# HAY CREEK VALLEY

## FINAL DRAINAGE REPORT

EPC STORMWATER REVIEW COMMENTS  
IN ORANGE BOXES WITH BLACK TEXT

Project No. 22.886.076

DP-14 - Q5

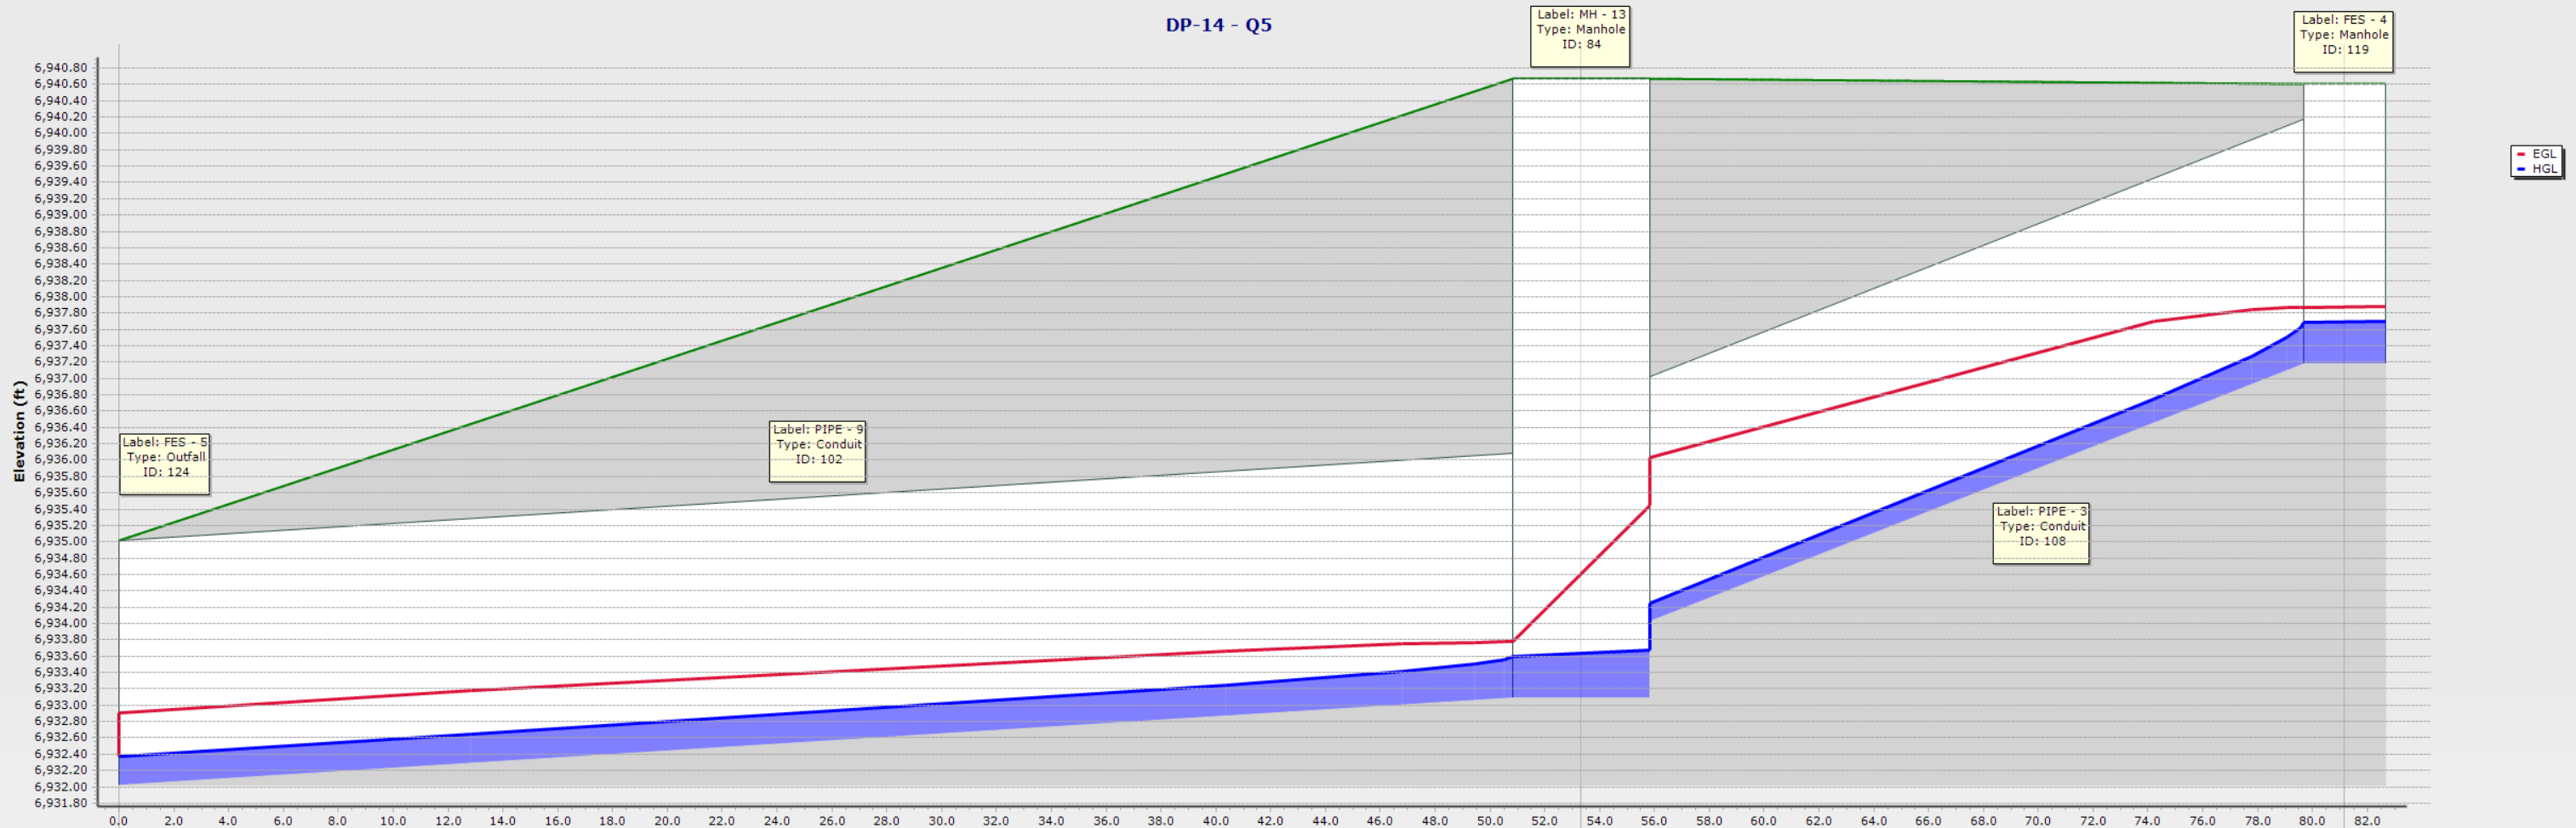
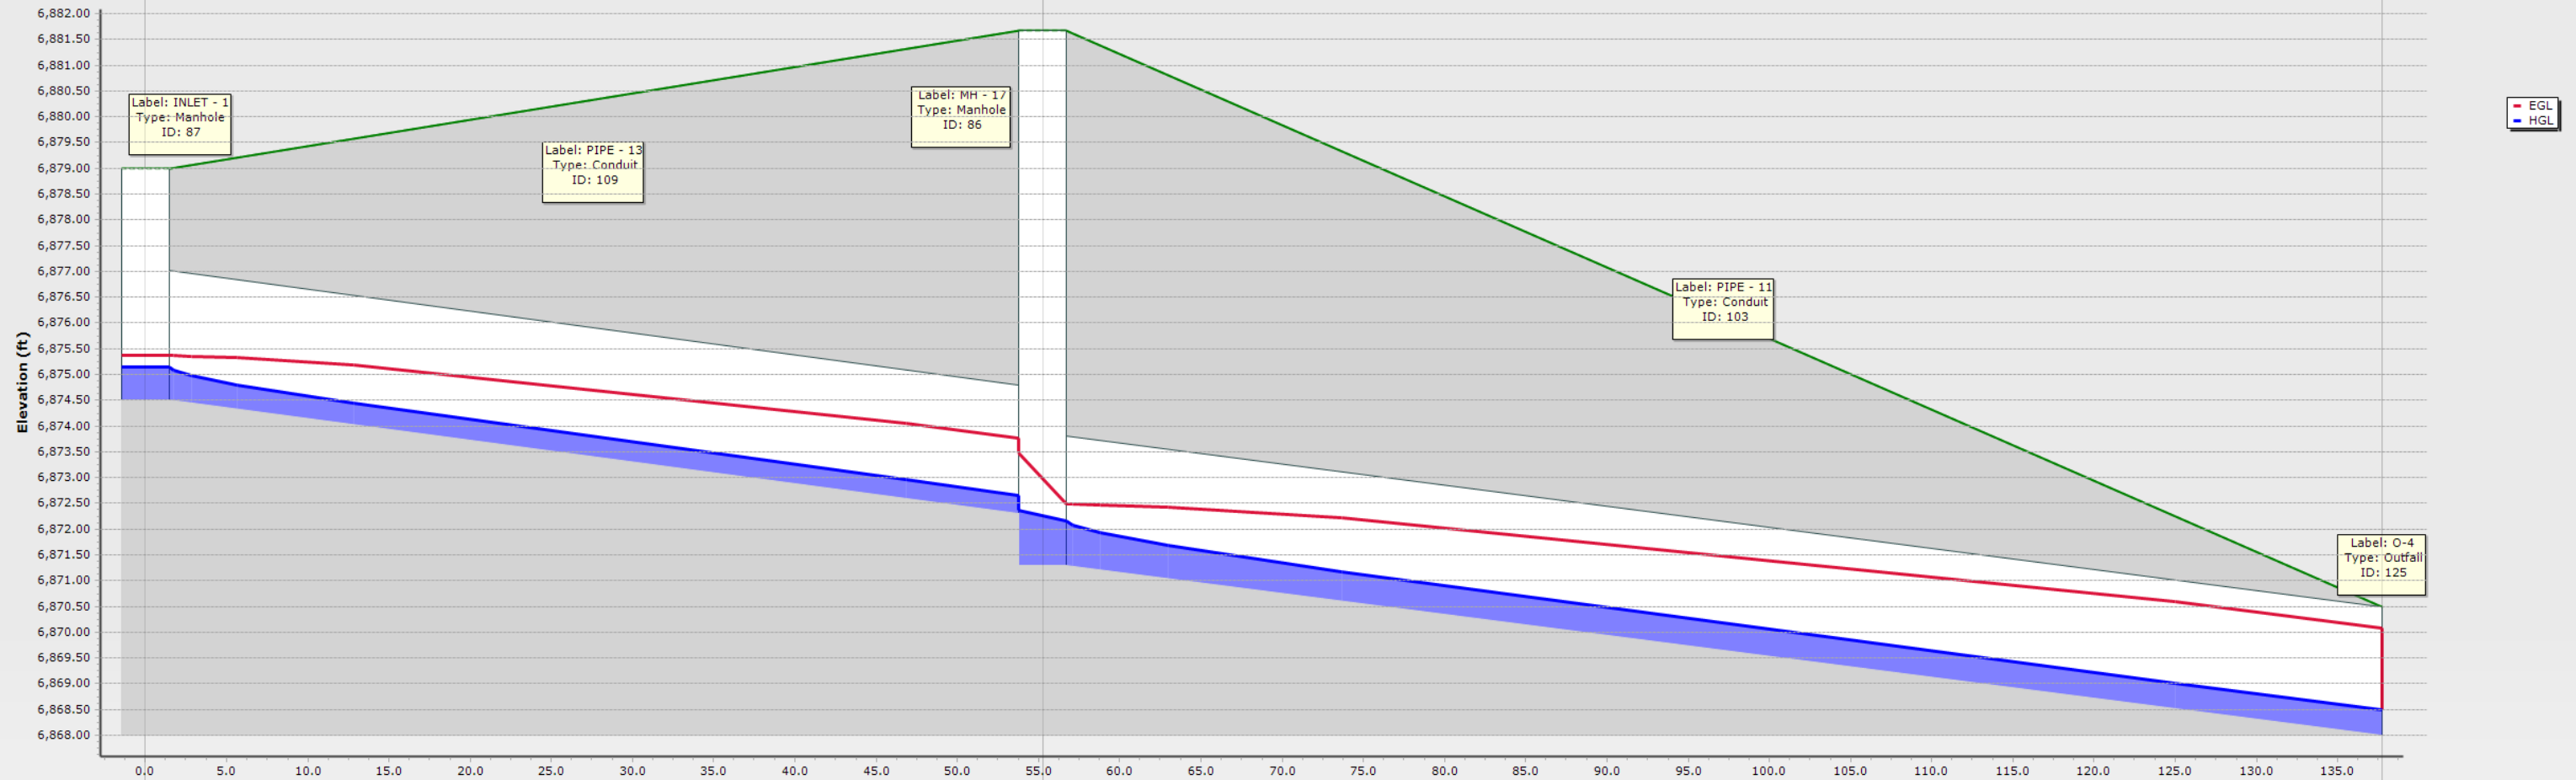
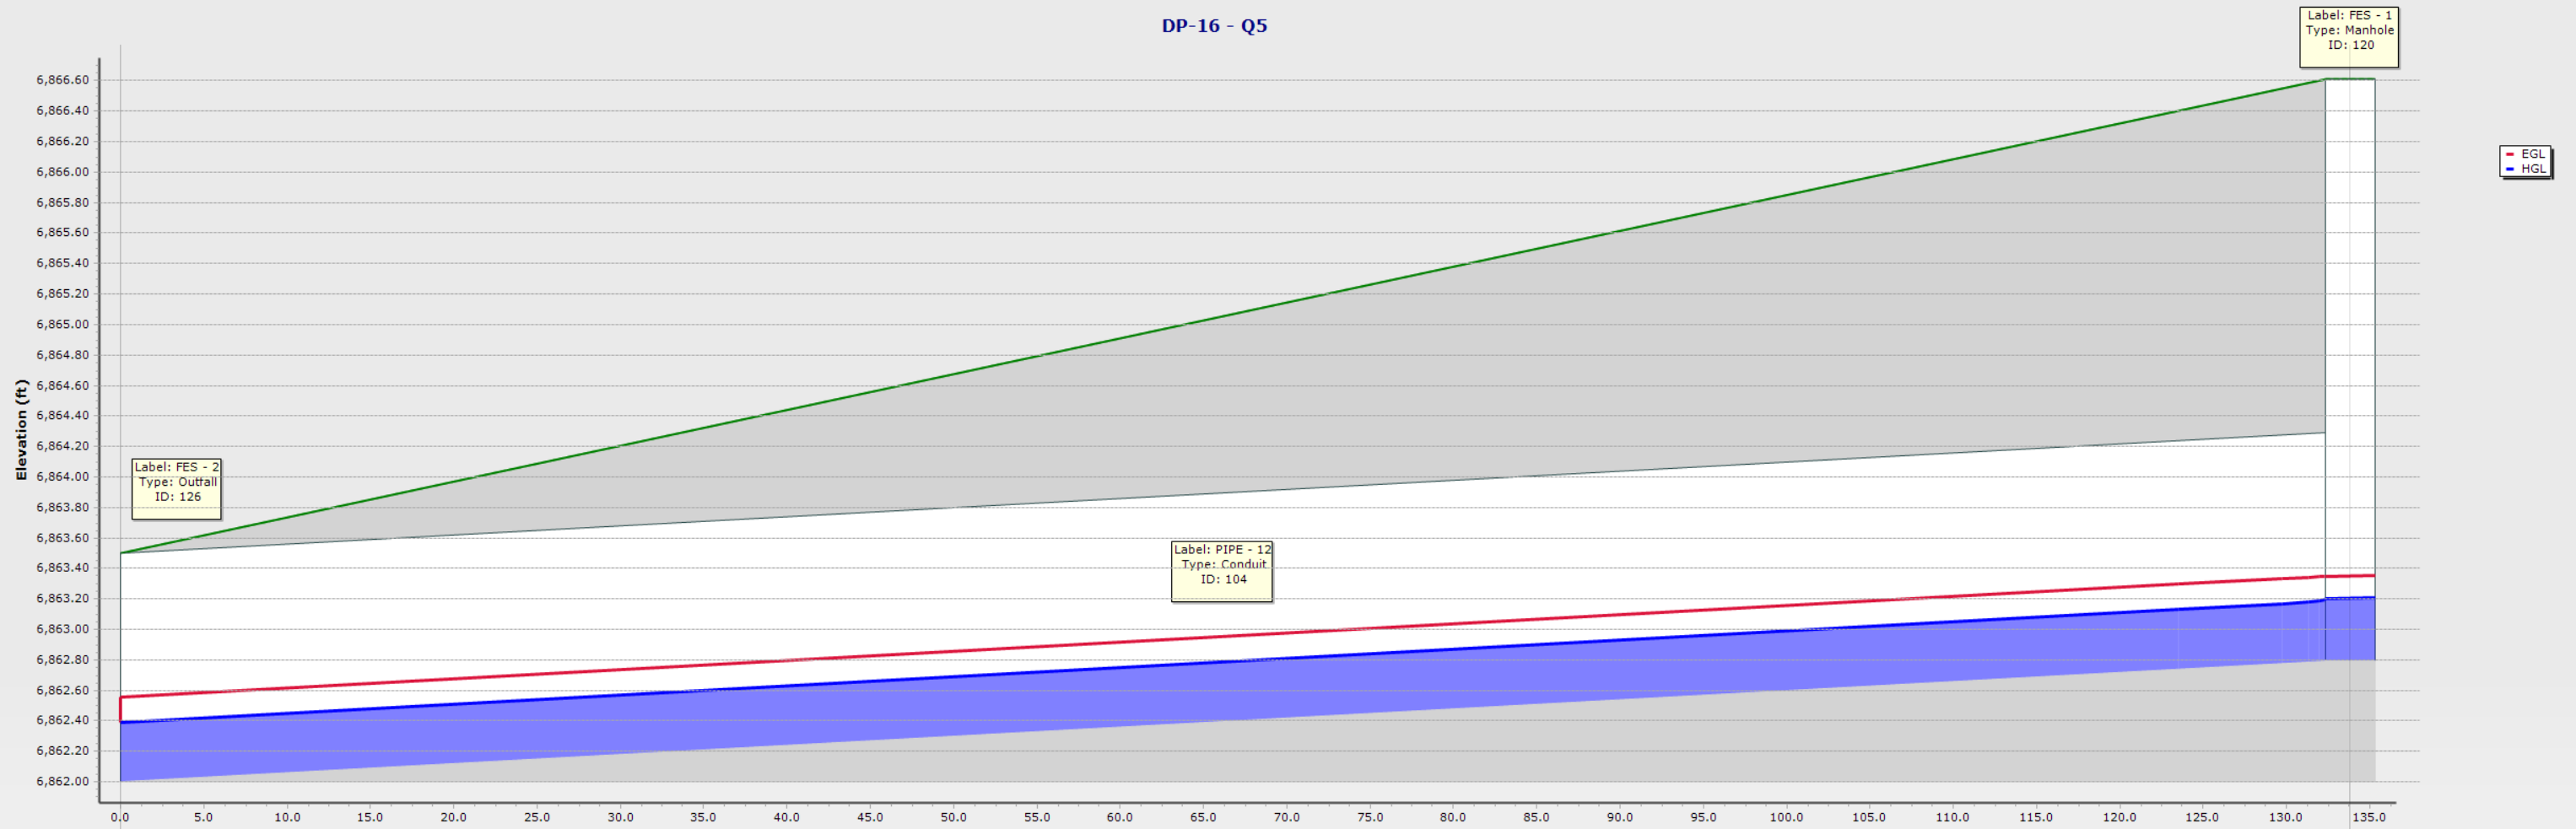
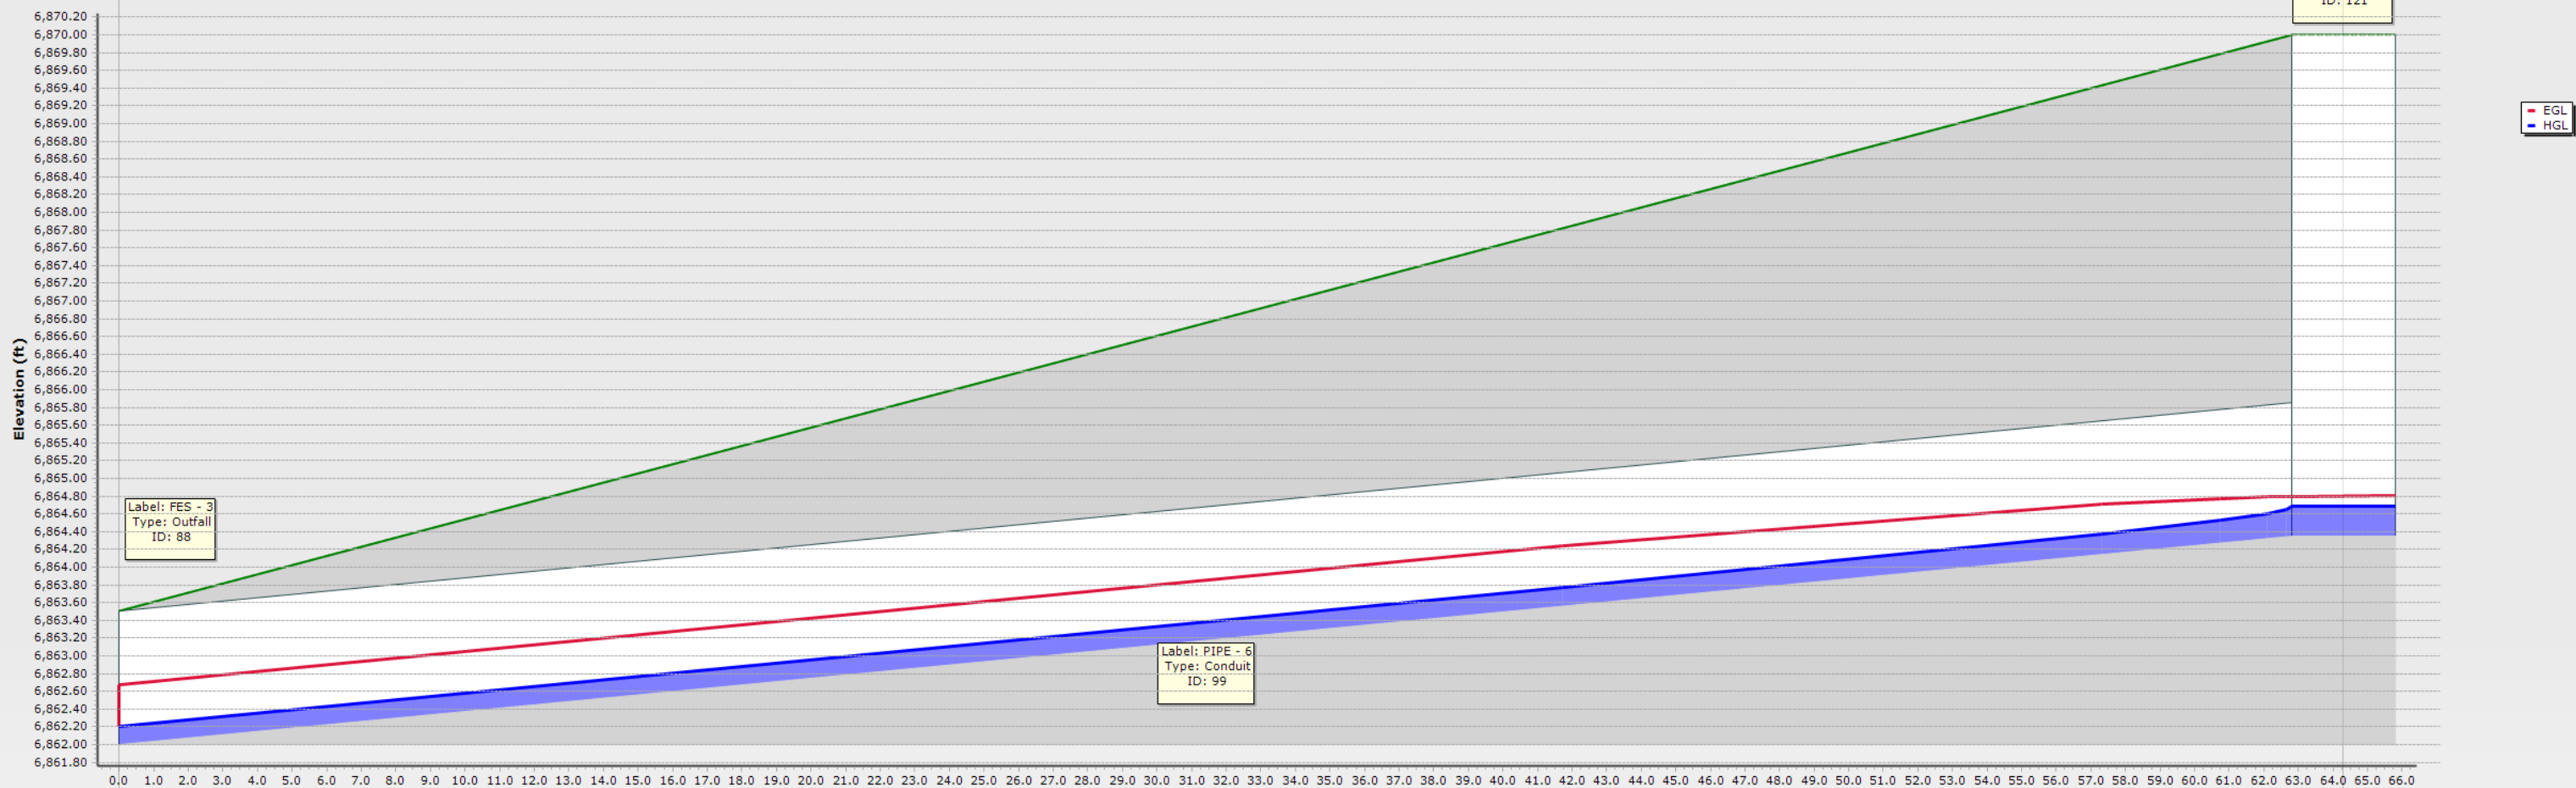
why is free outfall selected and tailwater is not analyzed for 6 of the 7 storm drain outfalls? If there's a reason please add a note/discuss.
